# **CITY OF PORT ALBERNI PUBLIC SAFETY BUILDING RENOVATIONS**

## **Addendum #3**

### **REQUEST FOR PROPOSAL RFP 024-21**

#### **Contractor Questions and Answers**

**Question 1:**

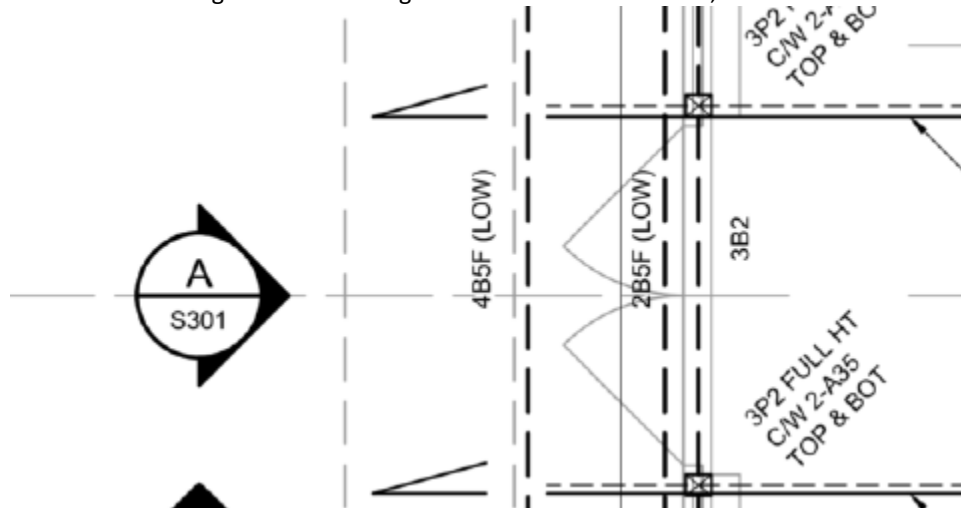
1. We putting together the pricing for this project and I wanted to confirm that we'll be ok to bid as equal with Samsung against the below Mitsubishi system.

It looks like the specified model has low ambient cooling down to -40F. The system that I would propose will only have low ambient cooling to 0F (-18C). I suspect that 0F will be sufficient for Port Alberni's climate, but I wanted to confirm.

***Samsung is acceptable.***

**A** **ELEVATION**  
S203  $1/4" = 1'-0"$

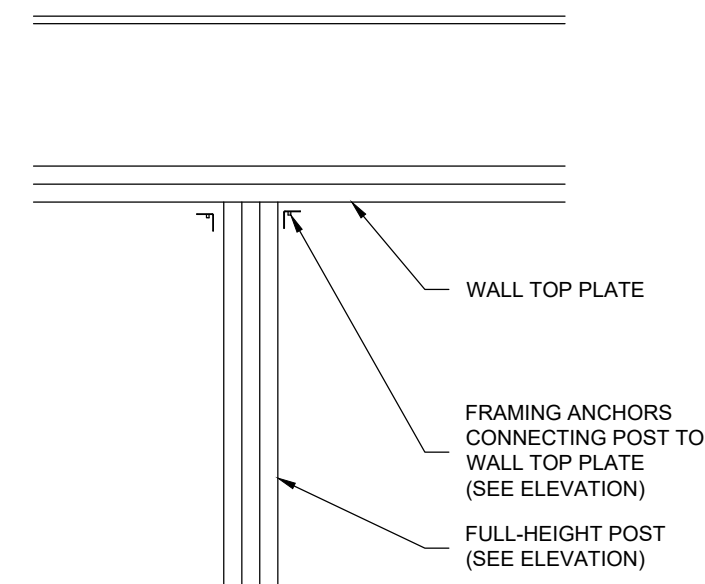
2. Structural - Rebar Contractor requires more details on the Foundation Footing and Wall rebar, spacing, type required for both
3. Structural – Provide Strength of concrete required for foundation, Interior and exterior sog.
4. Structural – Missing Elevation A - Page S301 as referred to below;

***The addendum needs to be used in conjunction with the building permit set (see attached). The addendum pages (S203) supersede those in the permit set.***
